Petition No. 2020-044

Petitioner: Charlotte Planning, Design and Development

**AN ORDINANCE AMENDING APPENDIX A OF
THE CITY CODE –ZONING ORDINANCE**

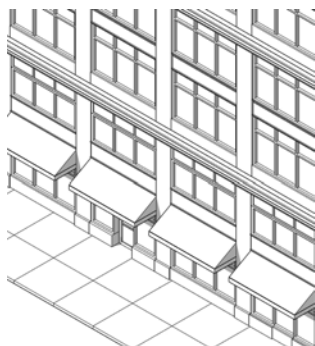
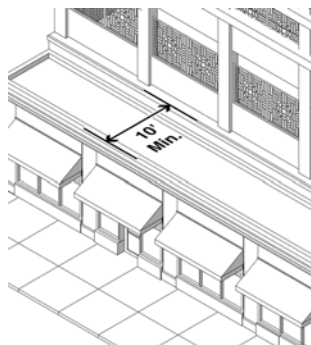
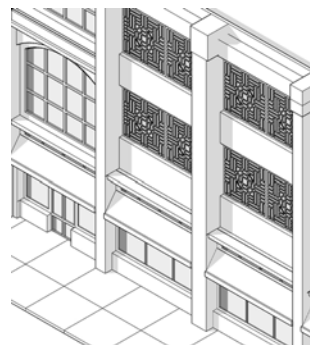
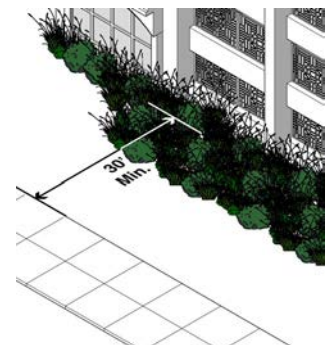
27. Amend Table 15.3, “Parking Structure Frontage Standards”, by the following:
- Clarify the text in the first asterisk, (*).
 - Update the section reference in the second asterisk, (**).

- Add a new triple asterisk (***) and text to the footnotes.
 - Add a triple asterisk (***) to the first column in the “ Limited Access” row.
 - Modify the captions under the graphics.

The revised table and graphic captions shall read as follows:

* All floors wrapped requires a minimum of 70% of the façade above ground floor along any primary frontage to be covered with occupiable building space a minimum of 20 feet in depth. This does not apply to where the façade is not viewable from any frontage or where the for the portion of the façade is beyond 6 stories, above the 6th floor.

** Landscaping shall run the full length of the setback zone, with the exception of areas of vehicular or pedestrian access. The landscaping area shall meet the requirements set forth in Section ~~15.6.6~~ 15.6.7. Such landscaping area shall count toward any required minimum build-to percentage.

*** Freight rail corridors are exempt from this requirement.

**Ground Floor Activation
+ Ground Floor Active +
All Floors Wrapped**

**Active Ground Floor Activation + 10'
Minimum Stepback for
Parking Above**

Ground Floor Active Activation Only

Parking Structure at Min. 30' Setback Line with Landscaping

Transit Trail and Planting Strip Dimensions

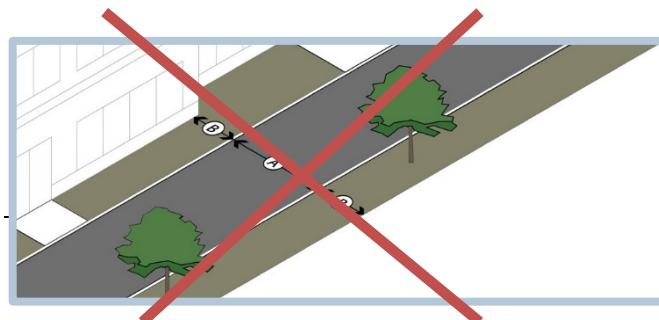
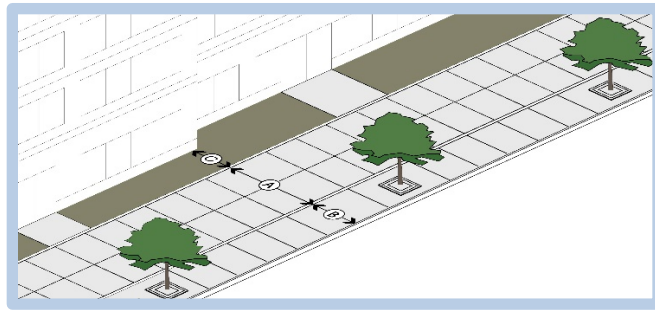
31. Amend Section 15.4.4, “Pedestrian Facilities and Planting Strip/Amenity Zone Standards”, subsection B, “Transit Trail” by deleting the term “perimeter” from the Transit Trail and Planting Strip Dimensions Table, located in the second column of row B. In addition, delete the term, “only” from the first footnote. The revised Table and footnotes shall read as follows:

Minimum Dimension
A	Transit Trail *	12'
B	Perimeter Planting Strip	4' on both sides **

* A transit trail is ~~only~~ required when the trail is identified in a Council-adopted plan.

** No trees will be required in the planting strip.

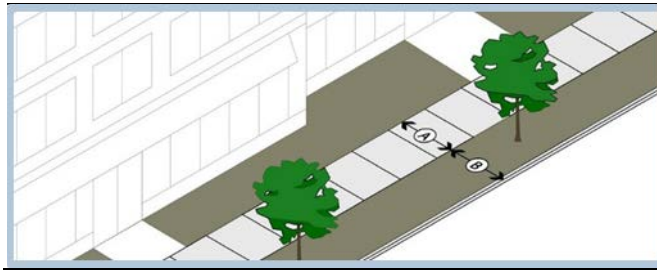
35. Amend Section 15.4.4, "Pedestrian Facilities and Planting Strip/Amenity Zone Standards", Table, "Sidewalk and Amenity Zone Dimensions" by deleting the term, "perimeter" from the double asterisk (**) footnote. The other footnote remains unchanged. The revised double asterisk shall read as follows:

** In TOD-TR, a ~~perimeter~~ planting strip is permitted in lieu of an amenity zone.

I. Cross Charlotte Trail (XCLT)*

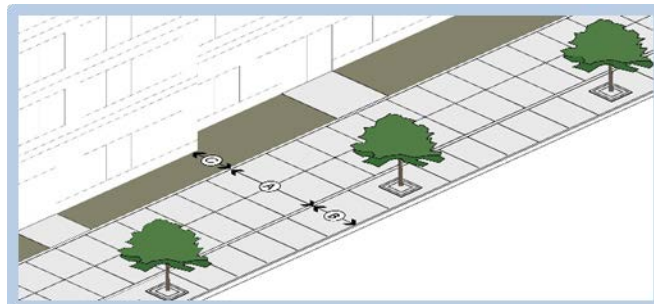
37. Amend Section 15.4.4, “Pedestrian Facilities and Planting Strip/Amenity Zone Standards”, by adding a new subsection I, titled “Cross Charlotte Trail (XCLT)*” that includes a new graphic, text, table and asterisk footnotes. The new Section 15.4.4.I shall read as follows:

Cross Charlotte Trail and Amenity Zone Dimensions**

* The Cross Charlotte Trail is required when the trail is identified in a Council-adopted Streets Map or adopted Area Plan. When the Streets Map or Area Plan indicates that the Cross Charlotte Trail (XCLT) is to be provided on a Limited Access frontage, the location of the trail will be determined by CDOT, and NCDOT if applicable.

Parking Lot Perimeter Landscape

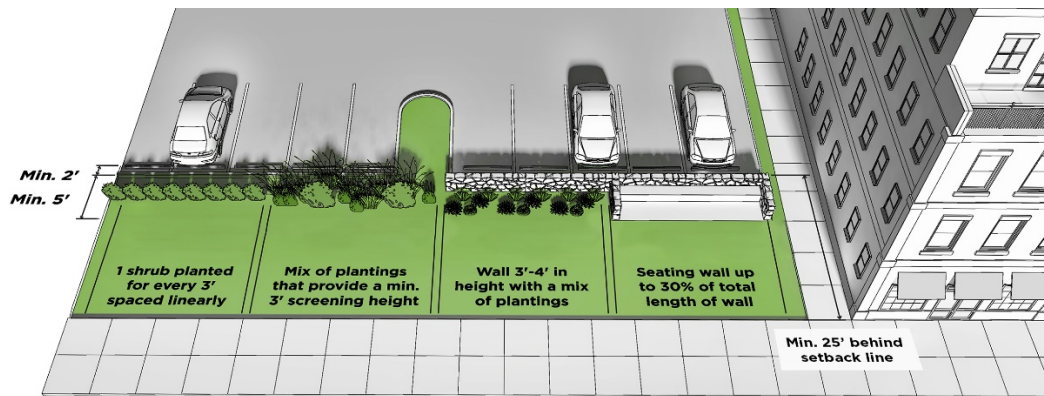
49. Amend Section 15.6.3, “Parking Lot and Loading Area Perimeter Landscape” by replacing the existing graphic with a new graphic. The deleted and new graphic is as follows:

K. Utilities, (On-Site) Above Ground Accessory Structures

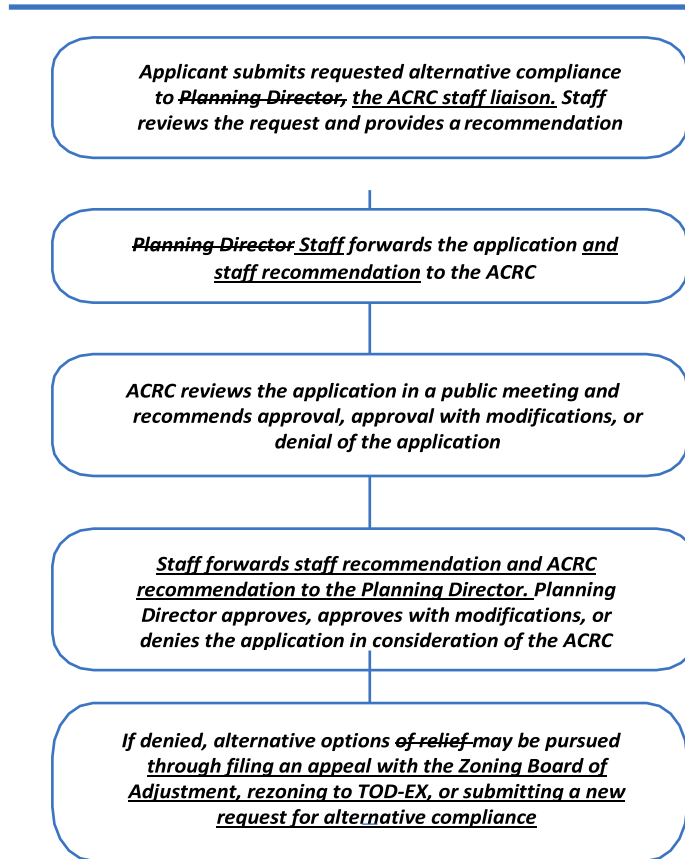
2. If a fence or wall is used to screen a large waste container or recycling station, the fence, gate and wall shall be constructed of the materials allowed in Section 15.9.E.2.
 23. Location and screening requirements of large waste containers and recycling stations are eligible for alternative compliance (Section 15.11.2)
64. Amend Section 15.9, “Accessory Structures”, subsection K, “Utilities (On-Site)”, by retitling the section to “Utilities, Above Ground Accessory Structures”. In addition, modify Sections 15.9.K.1, 2, and 3. Section 15.9.K.4 remains unchanged. The revised Section 15.9.K shall read as follows:

1. All above ground accessory utility structures ~~on-site utilities~~ shall be located to the side or rear of the structure, unless placed ~~underground or~~ within the structure.

2. All above ground accessory utility structures associated with electric, natural gas, water, wastewater, stormwater, sewer, telecommunications, or cable television shall be located behind a required setback line, except as allowed by any City right-of way ordinances. This includes air vents, vaults, and backflow preventers.
